AMENDMENT 5

**Invitation for Bid (IFB)
UOG IFB No. B23-01**

QUESTION & ANSWER SHEET NO. 3
July 25, 2023

UOG IFB B23-01: INVITATION FOR MULTI-STEP SEALED BIDS FOR CONSTRUCTION SERVICES

DWG NO:
2EP102

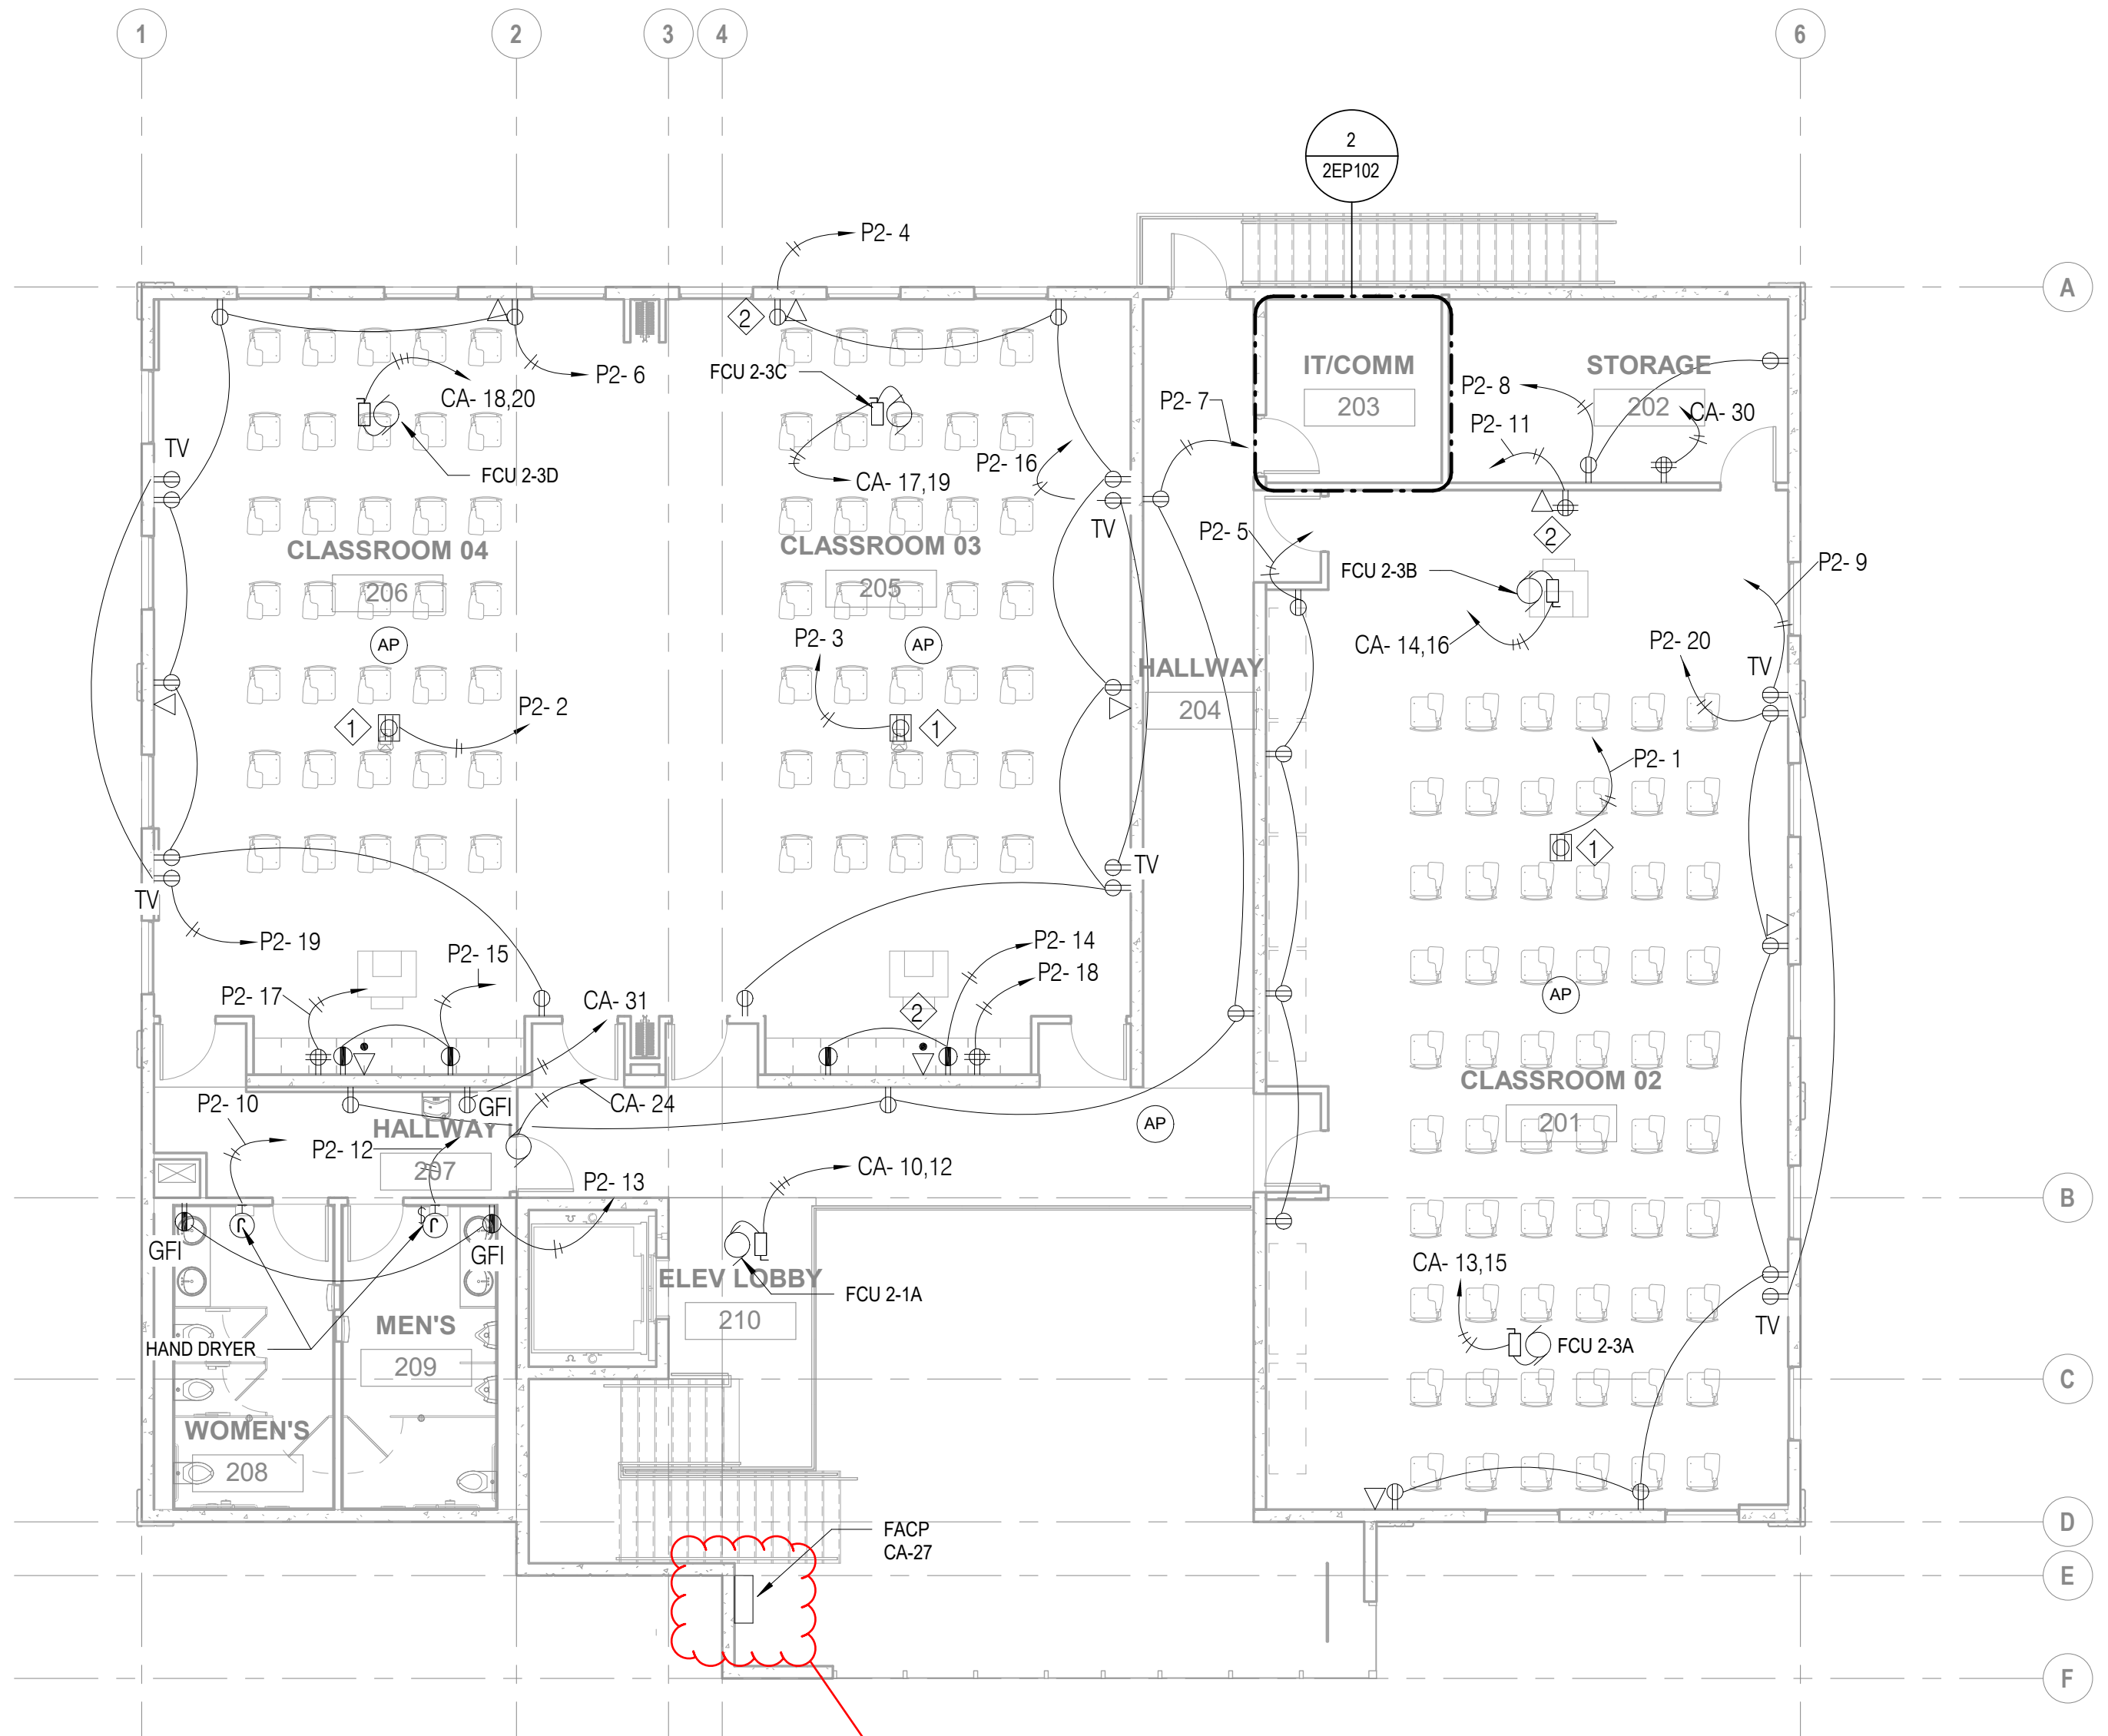
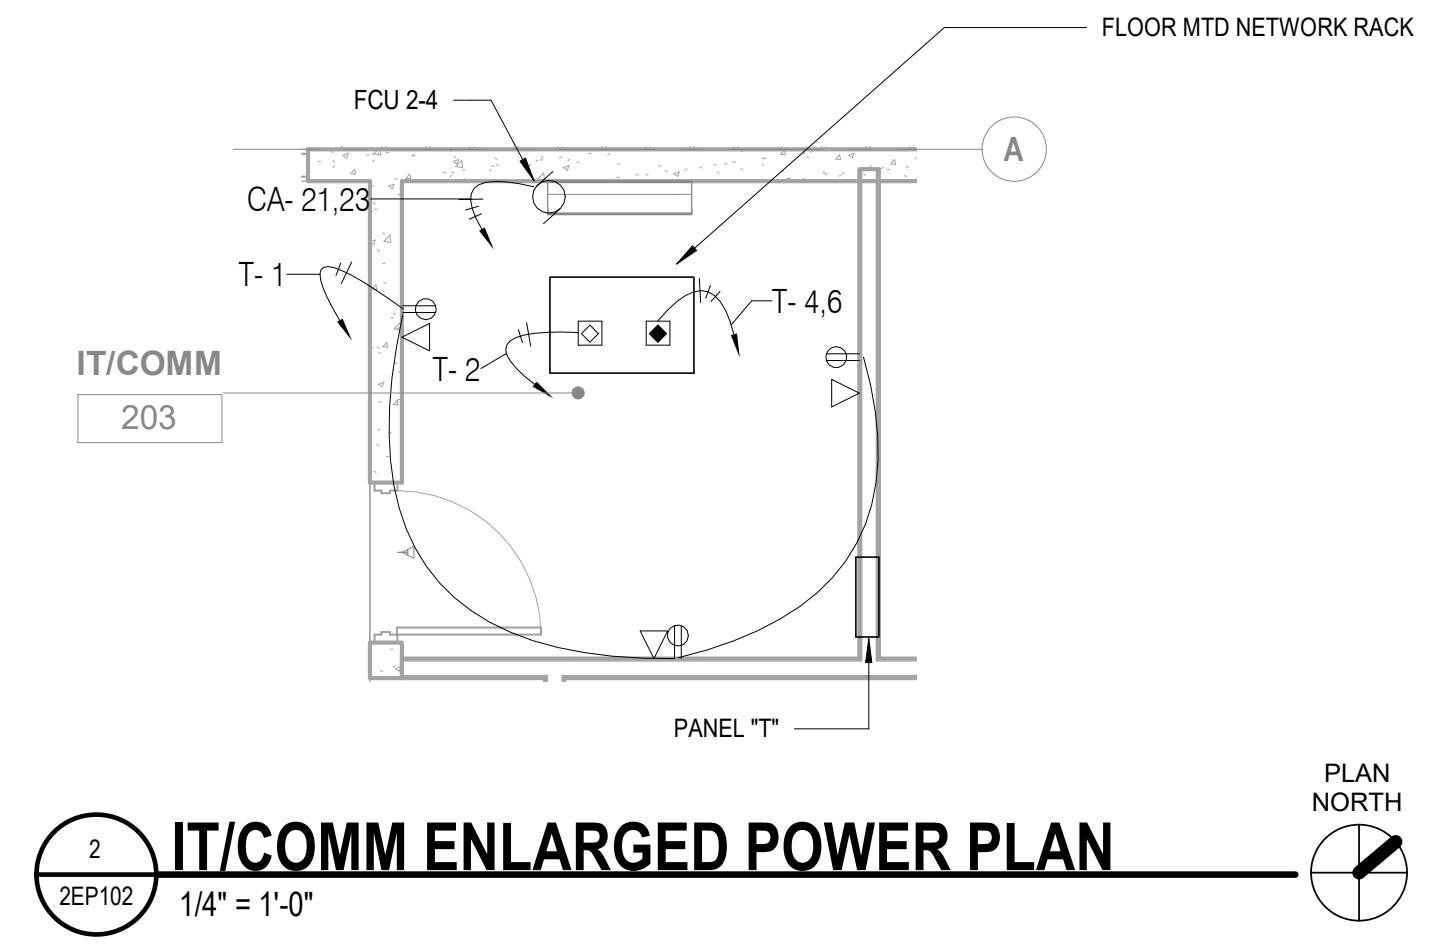
Please confirm if this will be provided by GC. Kindly provide the dimension / specifications if not.
